PROJECT ASSESSMENT REPORT			
<b>Unique Document ID and Revision No:</b>	ONR-OPF-PAR-16-010 Revision 0	<b>TRIM Ref:</b>	2016/294694
<b>Project:</b>	Sizewell B Dry Fuel Store		
<b>Site:</b>	Sizewell B		
<b>Title:</b>	Assessment of Sizewell B Dry Fuel Store Post Operational Safety Case, Stage Submission 1 Revision 1, NP/SC 7575, EC 338898-1		
<b>Licence Instrument No:</b> (if applicable)	No Licence Instrument Issued		
<b>Nuclear Site Licence No:</b>	63		
<b>Licence Condition:</b>	LC23(1) Operating Rules

Sizewell B Dry Fuel Store  
Assessment of Dry Fuel Store Post Operational Safety Case, Stage Submission 1 Revision 1  
NP/SC 7575, EC 338898-1

Project Assessment Report ONR-OPF-PAR-16-010  
Revision 0  
October 2016

Figure 1 showing MPC fuel element thermal loading pattern with individual fuel element limits. Ensuring 26kW maximum limit is not exceeded

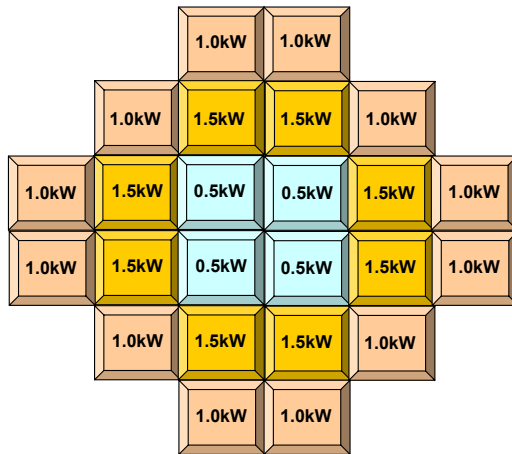
53. In determining the adequacy of control to ensure OR 2 is met, the ONR Fuel Inspector considers NGL has developed suitable and sufficient arrangements. This view is based on the use of 2 independent methods to calculate fuel element thermal output. Each approach is based on different computer codes that have proven track records in nuclear applications. This methodology allows a level of independent checking to be established given the same source data (the Station's fuel element database) is used in both cases.

54. The first method uses Westinghouse propriety CASKWORKS software. This code is a US nuclear industry standard that complies with US NRC requirements. The software calculates the thermal output of individual fuel elements using information held on the Station's fuel element database. It then generates an MPC fuel element loading plan as

- shown in Figure 1 by optimising all available fuel element combinations from assemblies stored in the station's cooling pond.
55. The second method was developed by NGL and uses PANTHER and FISPIN fuel performance computer codes. Tables of thermal output values for all fuel types in the Sizewell B fuel storage pond have been generated. Using fuel identities initially selected by CASKWORKS, their thermal output values are re-checked using NGL tabulated values. A trial was conducted to check the accuracy and repeatability of the process. The outcome was that both methods calculated similar thermal output values.

56. By optimising the fuel loading pattern, the thermal heat profiles across the MPC can be optimised [REDACTED]. This allows steady state thermal convection within the MPC to be established. The heat is dissipated from the MPC by conduction through its metal structure and radiation to the external environment.

58. The ONR Fuel Inspector concluded that NGL had developed suitable arrangements to confirm ORs and provide the assurance that identified requirements could be met.
